GPS, Pilots & ATC

GPS Approaches: Design & ATC

By Wally Roberts

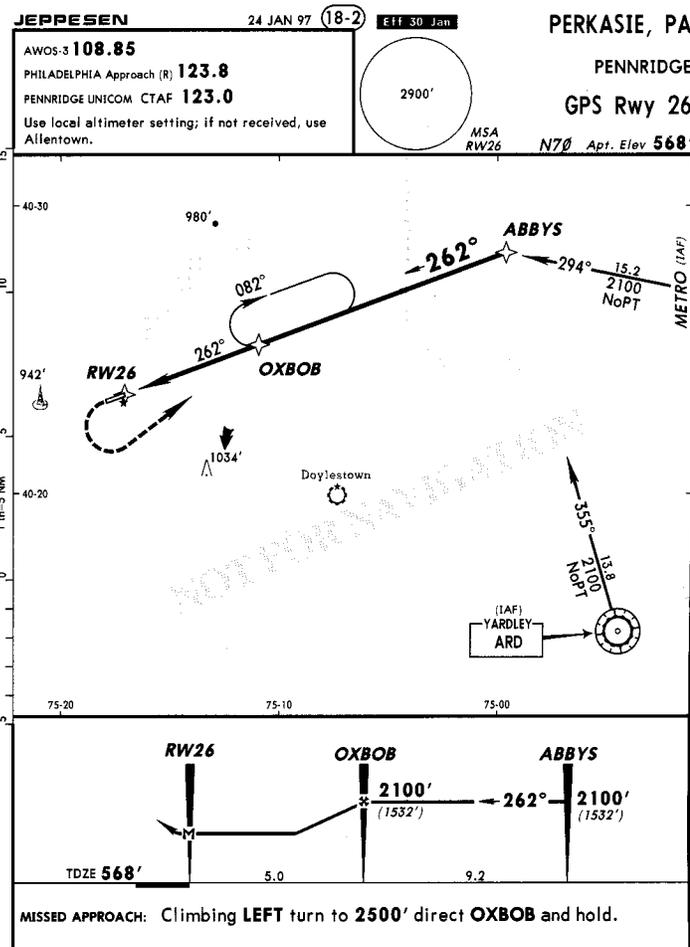
In the process of preparing for this article, I carefully reviewed the instrument approaches into Pennridge. On the GPS Runway 26, both initial approach segments (METRO-ABBYS and ARD-ABBYS) are marked "NoPT," yet there is no published course reversal on the chart. This is incorrect charting convention because

a route marked "NoPT" implies entry into the approach procedure from some directions requires a course reversal. All routes into an approach without a course reversal must meet "NoPT" alignment and descent gradient requirements. Therefore, "NoPT" should never be charted on an approach chart without a course reversal (holding pattern or bold-type holding pattern). I contacted the FAA about this charting error and was told it would soon be
(continued on next page)

corrected.

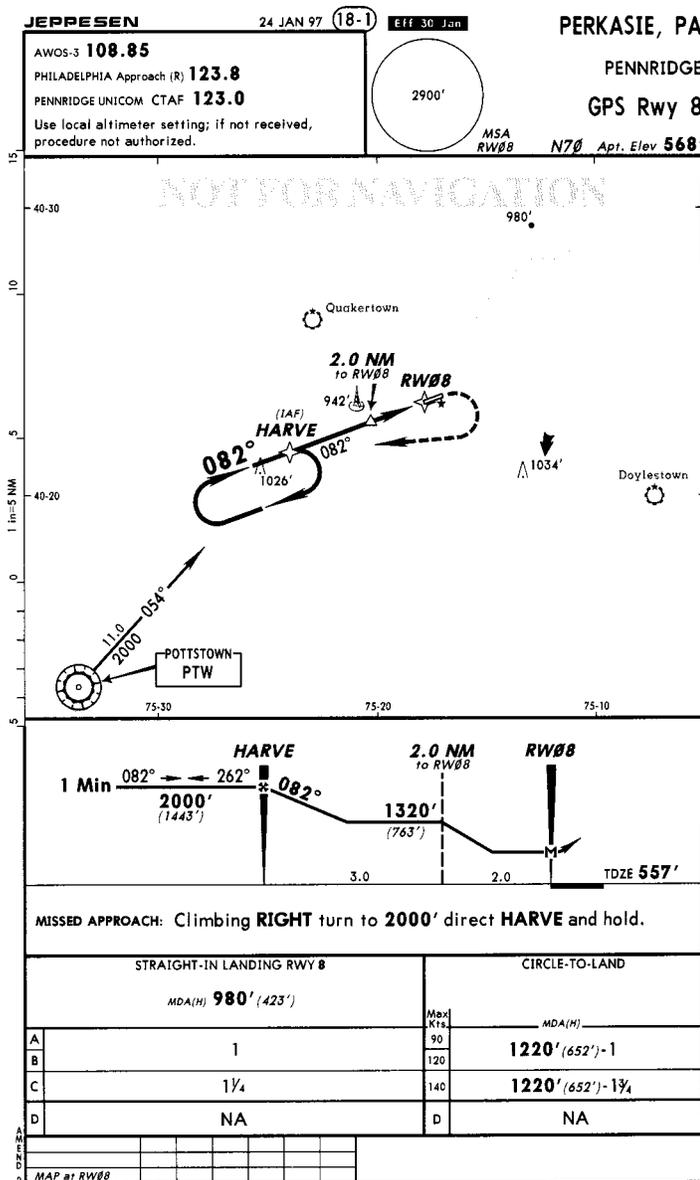
The only feeder route for this procedure is from PTW to HARVE. When proceeding via this route, you must execute the published course reversal at HARVE. The VOR procedure to this runway (see chart page 13) has a “NoPT” route from PTW. Since the airspace has already been evaluated, it wouldn’t be difficult to have a straight-in route for the GPS procedure as well.

Refer to the GPS Runway 8 approach chart (page 12). Note the terminal route from PTW isn't marked "NoPT," so a course reversal is required at HARVE for every non-radar arrival. This doesn't take advantage of the flexibility afforded by GPS. On the other hand, the VOR Runway 8 (page 13) approach procedure has a dog-leg off PTW to a NoPT-qualified intermediate fix. This is far better design and the GPS approach should have followed suit. I believe this is an example of an overloaded FAA procedures staff having to blindly follow a headquarters bureaucratic mandate to crank out 500 GPS approaches "no matter what." We all lose something in the process. The FAA has also agreed to fix this terminal route to look more like the VOR approach's initial approach segment from PTW.

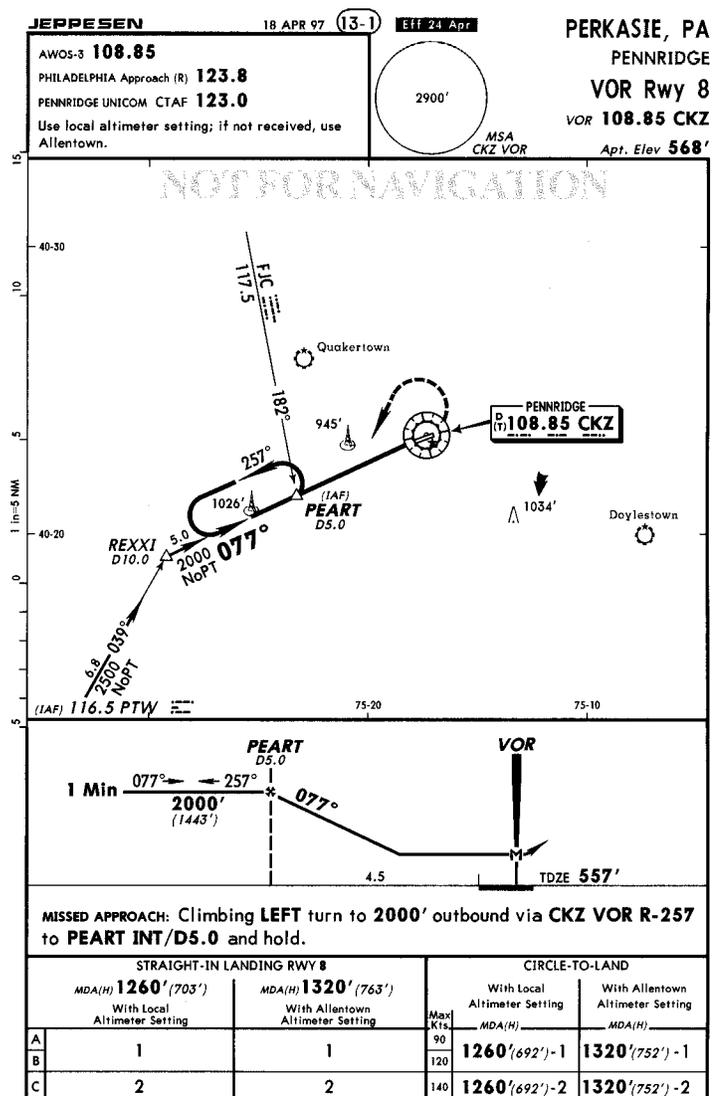
This procedure would have lower minimums if a DME step-down fix was placed inside the FAF, similar to the GPS Rwy 8 procedure shown on page 12. The FAA is presently evaluating the feasibility of adding a step-down fix and lower minimums. The 945-foot tower north of the final approach course is a determining factor.

Finally, I pointed out to the FAA that the VOR Runway 8 approach could have significantly lower minimums for DME-equipped aircraft if a DME step-down fix were located at the approximate same location as the 2.0 nm along-track-distance (ATD) or step-down fix on the GPS Runway 8 procedure. This step-down fix clears the 940-foot (+/-) hill with tower left of final approach centerline. The FAA has also agreed to look into establishing such a fix.
